STAFF REPORT

RE: 638 United Street (Landscape Sec 108 Review) addressed as 634, 636, & 638 United Street and 1302 Villa Mill Alley.

FROM: Karen DeMaria, City of Key West Urban Forestry Manager

1 LANDSCAPE PLAN
Scale: 1"=10'-0"

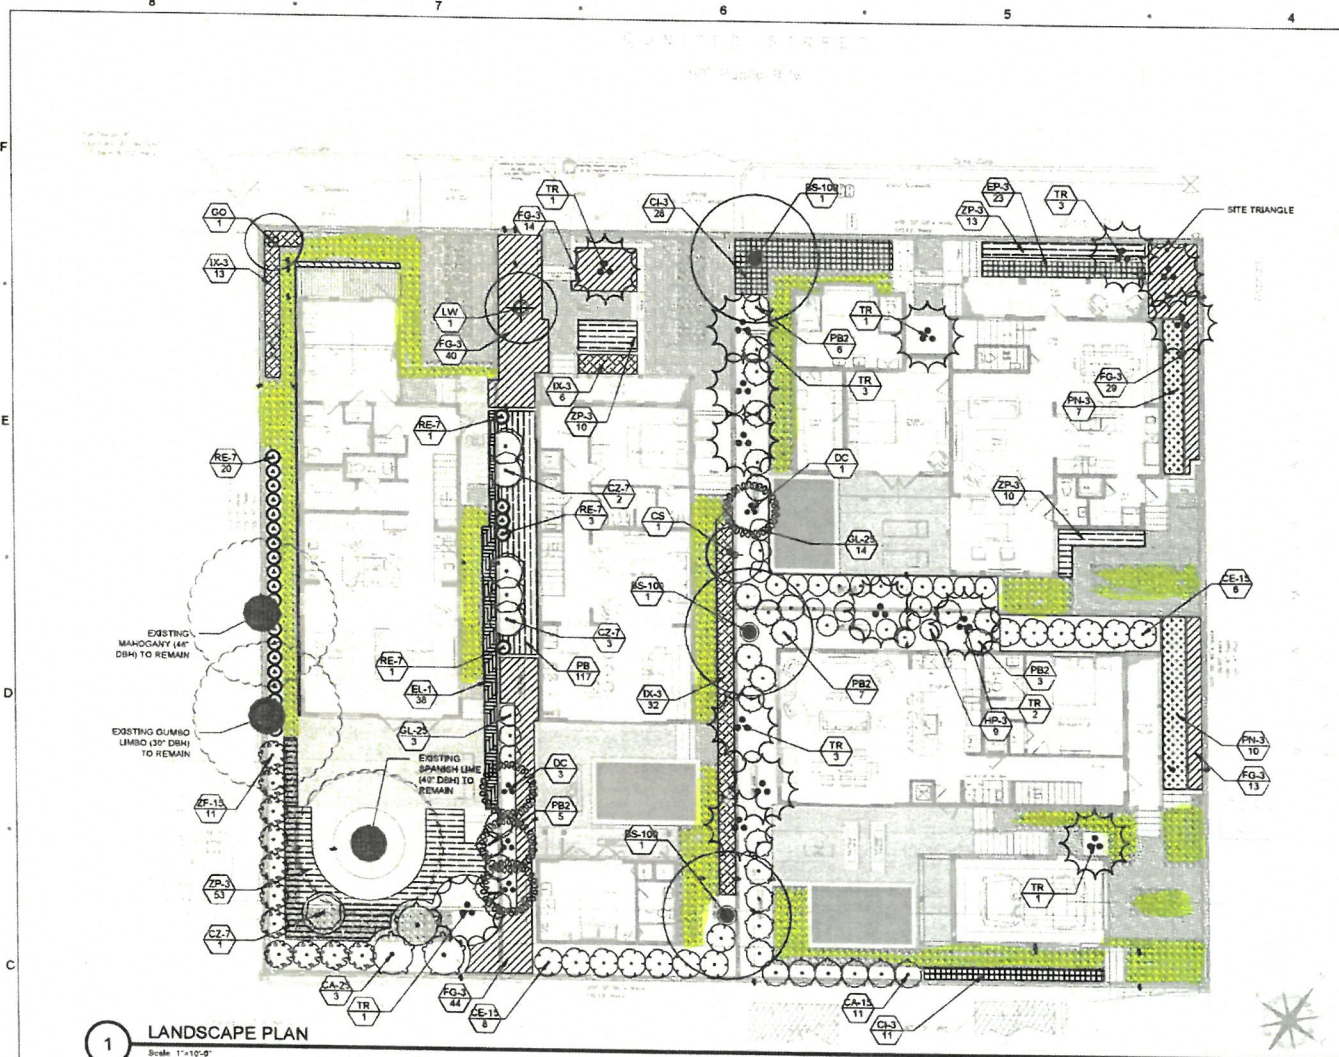
1. Sec 108-243: An updated, existing tree map, a tree protection plan, and a landscape plan has been submitted. **The landscape plan is not sealed. No irrigation plan has been submitted.**
2. Sec 108-289: The project received Conceptual Landscape plan approval with tree removal at the October 16, 2023 Tree Commission meeting (TP2023-00005) to include the removal of (9) young Spanish Lime trees including tree #3, #5, & #6b, (1) Gumbo Limbo (tree #7b), (2) Arborvitae (tree #7a & #8), and (1) Fishtail Palm (tree#6a NPR) to be replaced with a total of 29.1 caliper inches of approved trees from the approved list, to be planted on site and incorporated into the landscape plan. The fishtail palm is not regulated.

Along the rear, approximately 40 shrubs of various heights will be planted (Clusia, Silver Buttonwood, Cocoplum, Cardboard Palm and Green Island Ficus) for a total of approximately 40 plant units. Code requires the planting of 64 plant units in the 132.6 linear feet. **WAIVER NEEDED.**

Along the southwest property line area, there are two large existing canopy trees. Approximately 36 shrubs (Ixora, Cardboard Palm and Lady Palms) will be added for a total of 76 plant units in the 105.5 linear feet area. Code requires 47 plant units for this area.

7. Sec 108-412: The proposed modified plan states 23% percentage of the property is to be landscaped. The plan does not incorporate over 70% native vegetation. The plan is 70% native and indigenous plants (Ixora and Green Island Ficus, two common plants in Old Town). The Tree Commission gave approval for this plan based on the native and indigenous percentage being over 70%. It appears that the rest of the property not covered in hardscape or groundcover will have gravel placed. **WAIVER NEEDED**

Along Villa Mill Alley, code requires 40 plant units in a 10 ft wide landscape area. The plan proposes a consistent 5 ft wide landscape area. Proposed vegetation to be planted totals 62 plant units.

Along United Street, code requires 54 plant units in a 10 ft wide landscape area. The plan proposes a consistent 5 ft wide landscape area. Proposed vegetation to be planted totals 90 plant units.

13. Sec 108-448: It does not appear that all landscape strips are covered with living material and/or mulch. No sod or grass is being proposed. Gravel is instead being placed in nonvegetative, open space landscape strips. **WAIVER NEEDED**

15. Sec 108-481: Shrubs must be at least 24 inches OA at planting. Specs in the landscape plan state 18-24"OA. Also, palms account for 67% of the total tree requirements, code states that palms shall not constitute more than 25 percent of the of the total tree requirements. The Tree Commission was presented with this information and approved the landscape plan, as submitted. **WAIVER NEEDED**

gravel areas 12-7-23 KD

Sec 108-347, only 40 plant units will be planted. Code requires the planting of 64 plant units in this area, the rear property line that runs off Villa Mill Alley.

Sec 108-412.b, the plan does not incorporate over 70% native vegetation. The plan is 70% native and indigenous plants (Ixora and Green Island Ficus, two common plants in Old Town). The Tree Commission gave approval for this plan based on the native and indigenous percentage being over 70%.

Sec 108-413, the code requires a 10 ft wide landscape area. The landscape plan proposes a consistent 5 ft wide landscape area. Waiver needed due to width of landscape areas.

Sec 108-448, gravel is being placed in landscape strips where trees, shrubs, or groundcover is not being planted. No sod or grass is proposed to be installed on the properties. This section of code requires grass or sod be planted.

Sec 108-481, shrubs are to be at least 24 inches OA at planting. Specs in the landscape plan state 18-24"OA. Also, palms account for 67% of the total tree

requirements, code states that palms shall not constitute more than 25 percent of the of the total tree requirements.

1. Sealed landscape plans must be submitted prior to City Commission review.
2. An irrigation plan must be submitted either prior to City Commission review or prior to building permits being issued.
3. The three existing, large, protected trees on the property that are to remain; 1-Spanish Lime (Tree #1), 1-Gumbo Limbo (Tree #2), and 1-Tamarind tree (Tree #4), are to be protected during all phases of the project. No impacts including to the roots, trunks, or canopy branches, are authorized to occur to these trees.
4. Final Landscape plan review is required. If no significant changes have been made to the project, the review can be done by the Urban Forestry Manager.
